5094/4412

**USE AND PARKING SURFACE VARIANCES TO ALLOW
THE OPERATION OF A RESTAURANT, CONTINUED USE
AS A BED AND BREAKFAST AND TO ALLOW A
LIMESTONE PARKING SURFACE IN AN R-1, SINGLE-
FAMILY RESIDENTIAL DISTRICT; A RESTAURANT
AND BED AND BREAKFAST ARE ALLOWED BY RIGHT
IN A B-2, NEIGHBORHOOD BUSINESS DISTRICT AND
PARKING SURFACES MUST BE ASPHALT, CONCRETE
OR AN ALTERNATIVE PAVING SURFACE.**

1306 DAUPHIN STREET

BOARD OF ZONING ADJUSTMENT

SITE PLAN

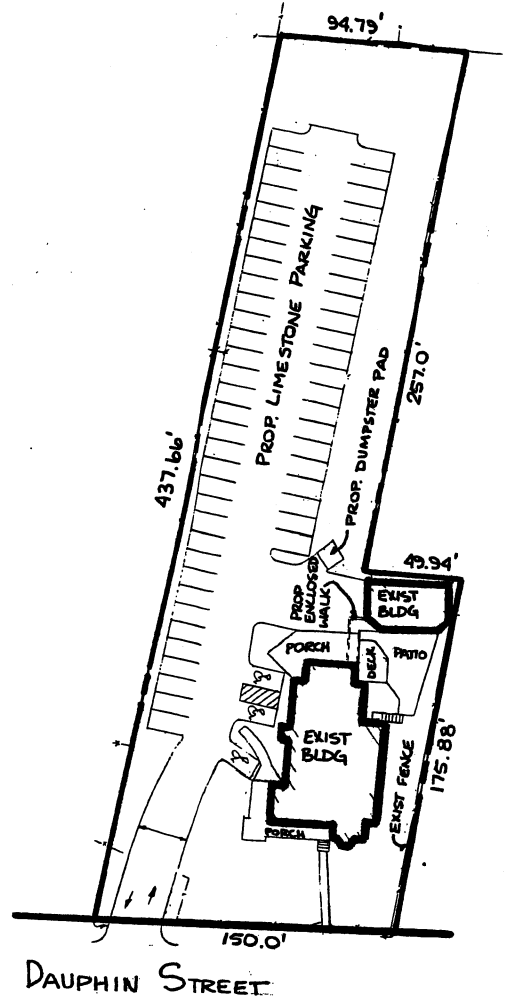
Regarding parking, the applicant proposes to remove the existing 1,500 square foot building, and fill in the swimming pool to make way for a limestone parking lot. The proposed number of parking spaces would comply with the requirements of the Ordinance. Furthermore, historic district review boards have shown a preference for gravel parking areas. However, there are problems associated with these types of parking lots such as gravel "creeping out" of the designated parking area, and no delineation of parking stalls. Therefore, if gravel parking is approved, the gravel parking area (including the driveway) should be contained with a concrete curb and individual parking stalls should be delineated with bumper stops.

Traffic Engineering conducted a site plan review and determined that the provision of cul-de-sac should be incorporated into the parking plan. The reason is that as parking spaces are occupied, and incoming traffic reaches the end of the parking lot, they would not have a place to turn around and exit.

The Zoning Ordinance states that when lighting facilities are used for parking areas, they shall be so arranged that the source of light does not shine directly onto adjacent residential properties or into traffic.

Based upon the preceding, this application is recommended for approval subject to the following conditions: 1) that the residential character of the primary structure be maintained; 2) that the proposed gravel parking area (including driveways) be curbed and contain bumper stops to delineate parking stalls; 3) the provision of buffering, in compliance with Section IV.D.1.a-d.along the West, North and East property lines; 4) the approval of the Old Dauphin Way Review Board for all external modifications; 5) the provision of a cul-de-sac at the end of the parking lot with the design to be approved by the Traffic Engineering Department; 6) the lighting facilities for the parking lot be arranged so they do not shine onto adjacent residential property or into traffic in accordance with Section IV.A.1 of the Zoning Ordinance; and 7) the emptying of the dumpster to be between the hours of 8 a.m. to 8 p.m. during the weekdays.
